Product Change Notice (PCN)

Subject: Change in Marking Format on Humidity Sensor HS3000 series

Publication Date: 4/25/2024

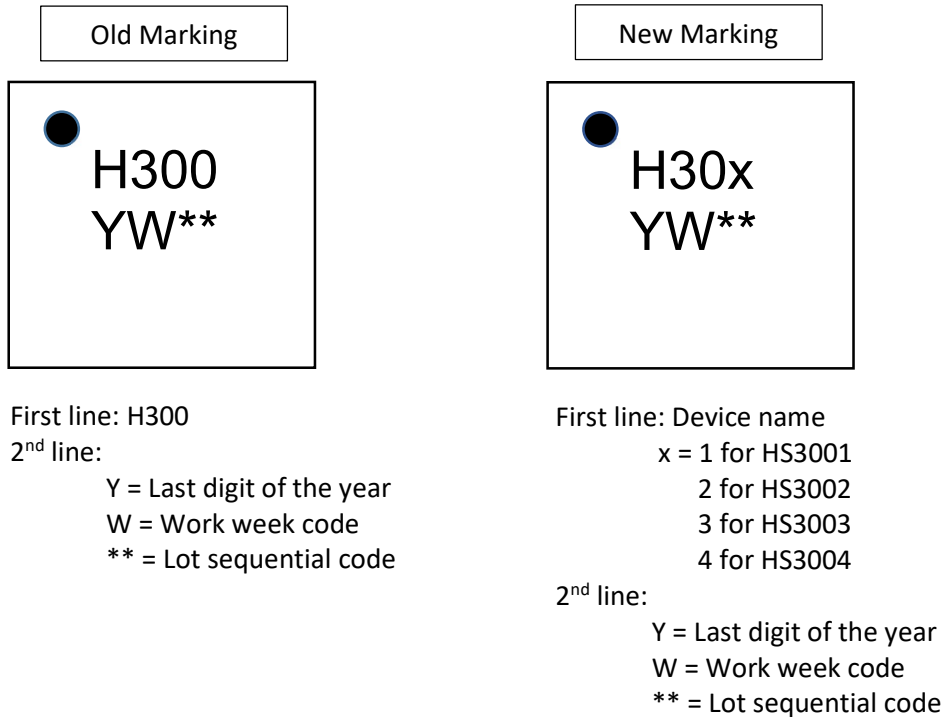
Renesas is changing the marking format on the first line as shown in the below diagram. There will be no change to form, fit, function, reliability and quality of the product.
